**Re: Response to REMA Comments  
Slate Upper School  
5100 Outer Ridge Road  
North Haven, Connecticut  
SLR #16156.00003**

SLR International Corporation (SLR) is in receipt of a letter from REMA Ecological Services, LLC, dated January 25, 2021, regarding the above-referenced project. We offer the following responses to the engineering comments contained therein:

**PROPOSED WATERSHED AREA TO WETLANDS**  
**SLATE UPPER SCHOOL**  
 5100 RIDGE ROAD  
 NORTH HAVEN, CONNECTICUT

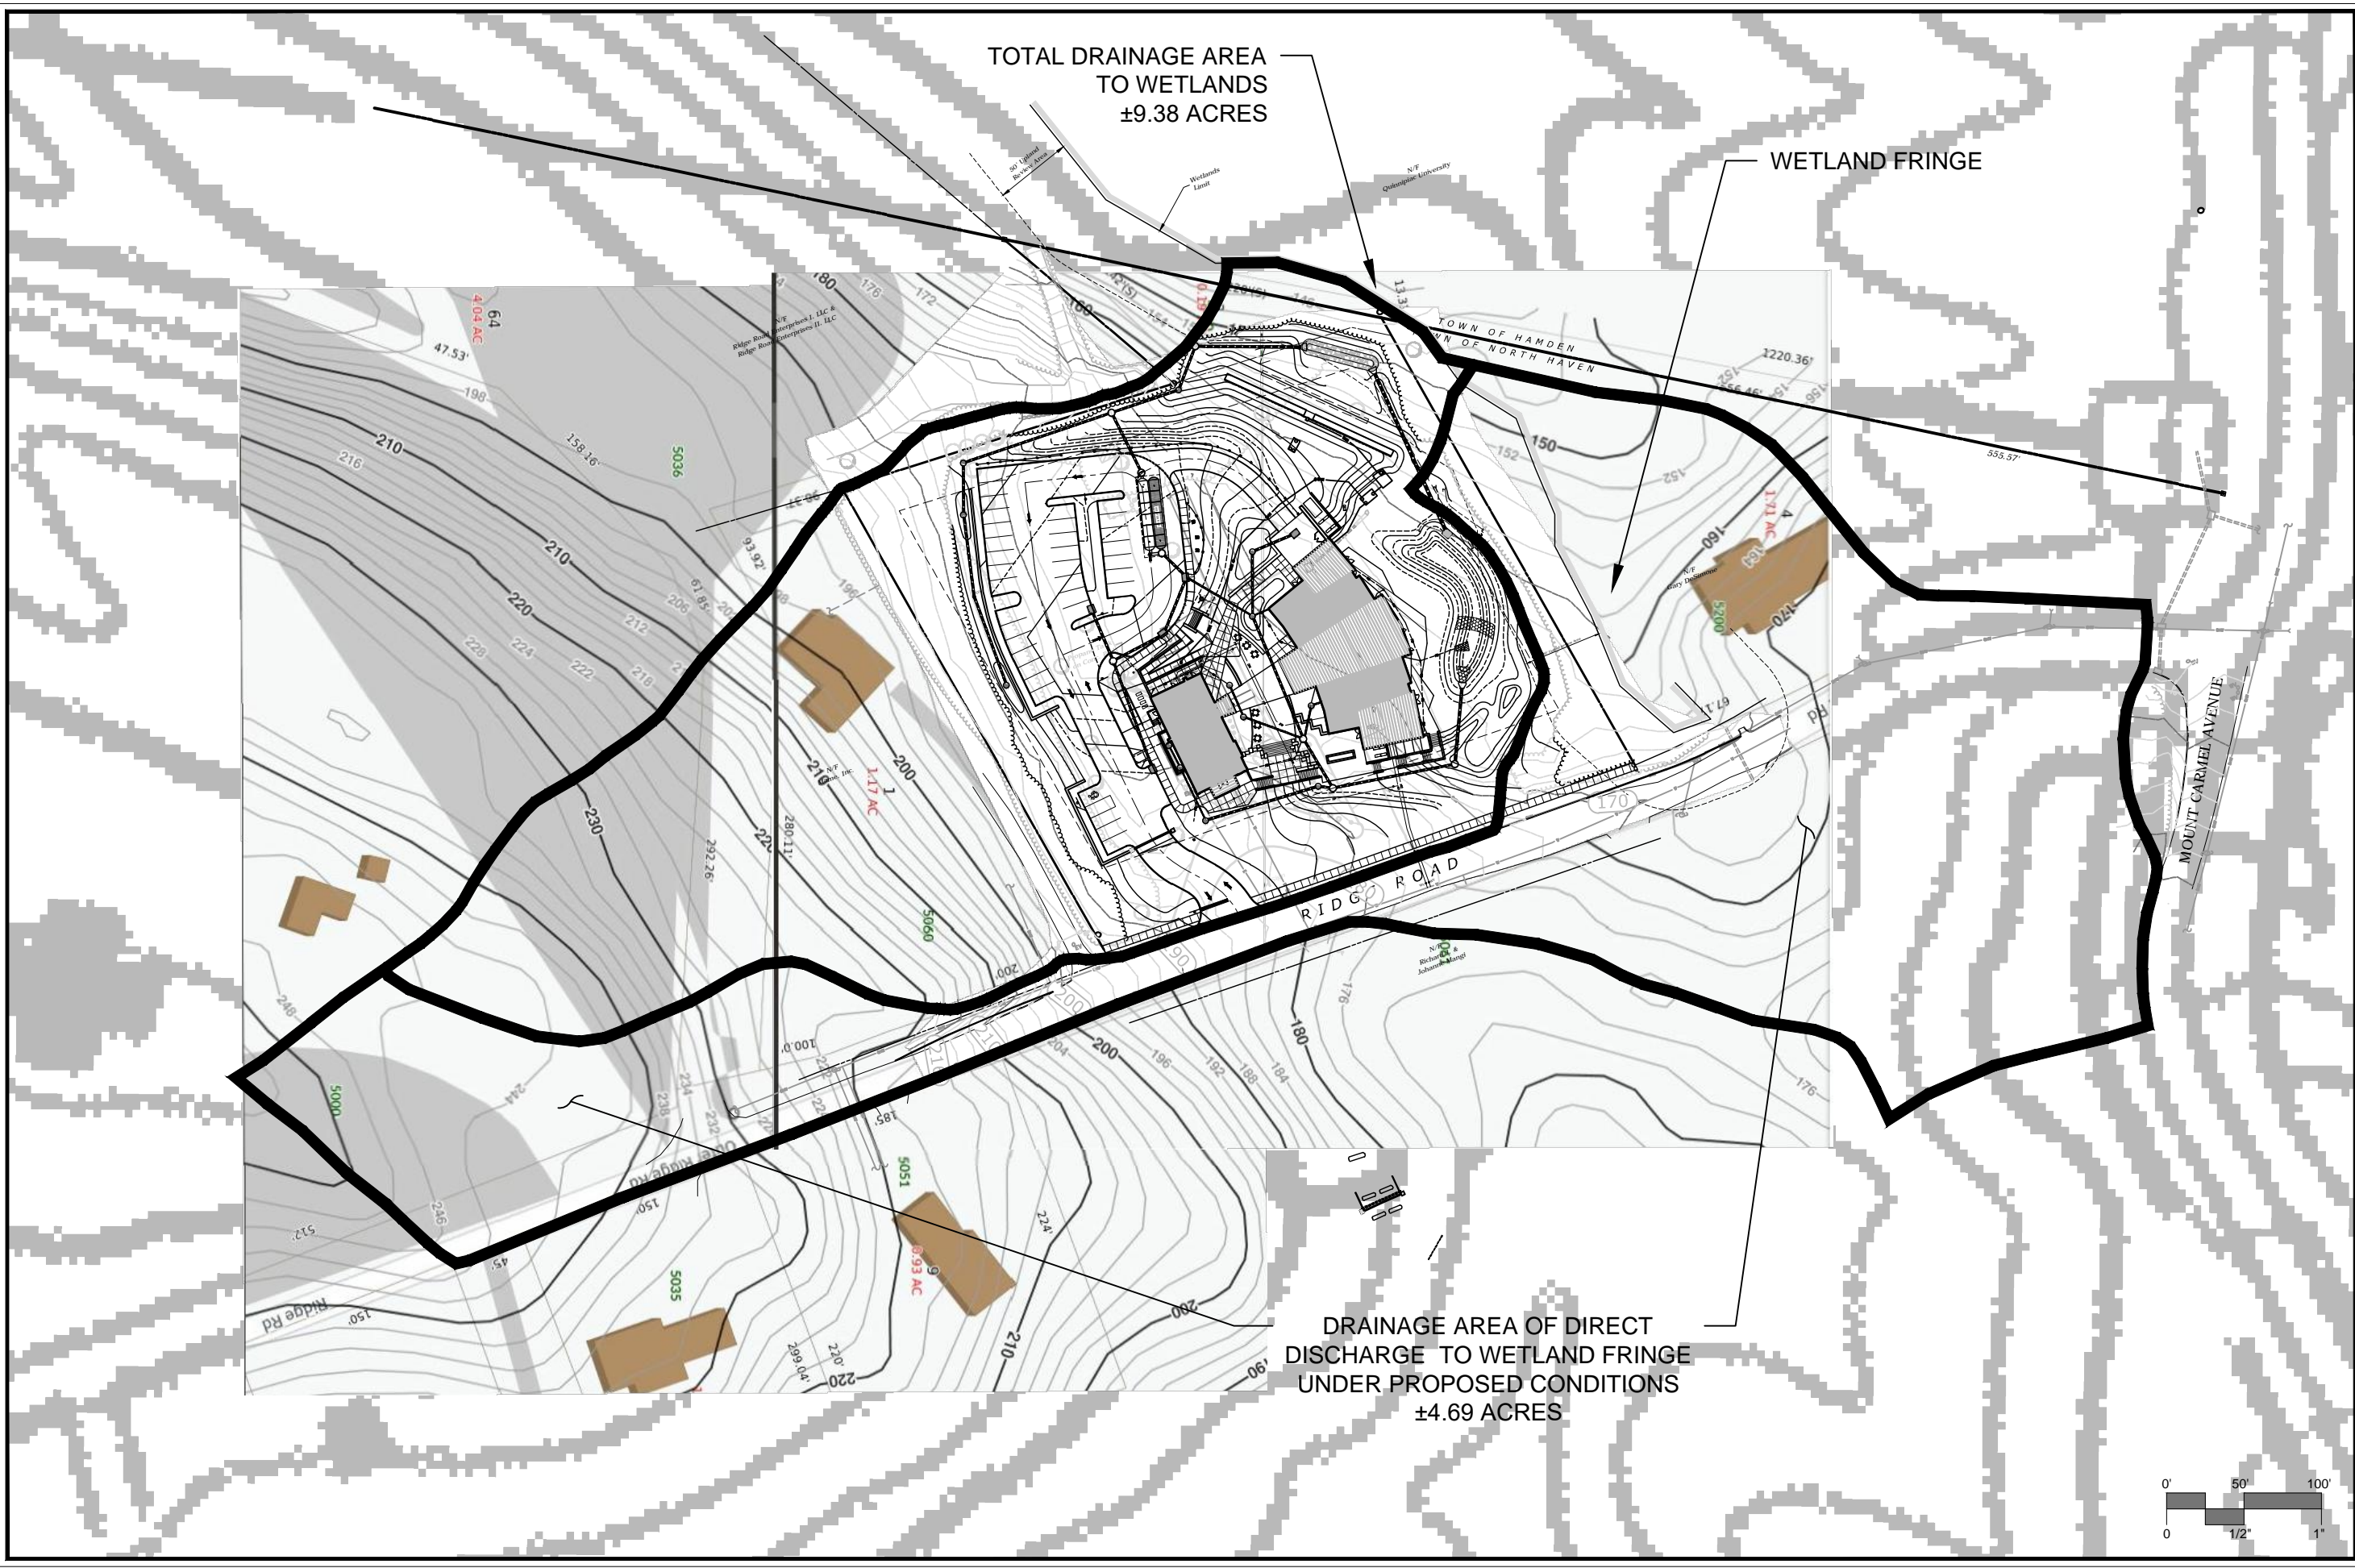
### **IMPACTS TO WETLAND HYDROLOGY**

Under existing conditions, the drainage area of the direct discharge to the aforementioned wetland fringe is 5.31 acres. Under proposed conditions, the direct discharge area to the wetland fringe will be reduced by only 0.62 acres (a reduction of 12% from existing conditions). This reduction in the drainage area will not cause a significant adverse impact to the wetland fringe. It should be noted that the proposed development will not cause a diversion that reduces the drainage area to the downstream wetlands off the property to the west. Illustrative watershed maps for both existing and proposed conditions are attached.
